Access Compliance Report

Public Rights-of-Way

(Curb Ramps)

Intersection ID: 46590	Main Street: QUAKING GRASS CT	Cross Street: RABBITS FOOT LN	Location: W
ADA ID: B1FC3E65E600	Ramp Type: PerpDiag	Initial Pass/Fail: Fail	Overall Compliance: No
Severity Score: 21.25			
Codes/Mitigation Info/Possible Solution		Field Measurements/Component Compliance

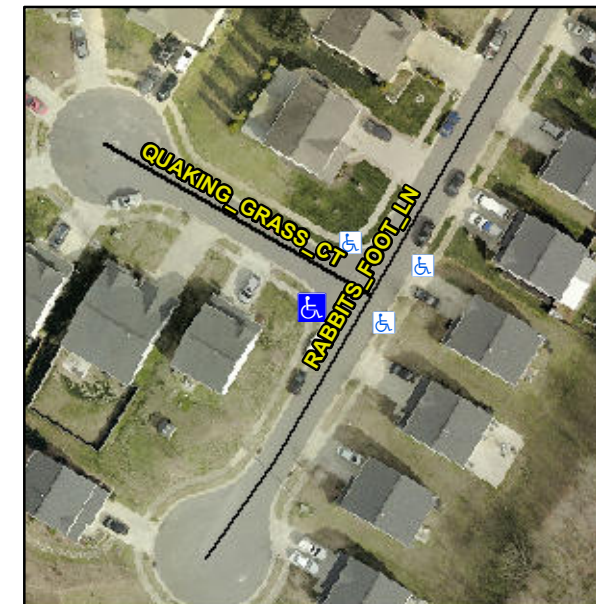
R304.5.1, R304.2.2

Remove & Replace Curb Ramp With Two New Directional Ramps or Equivalent.
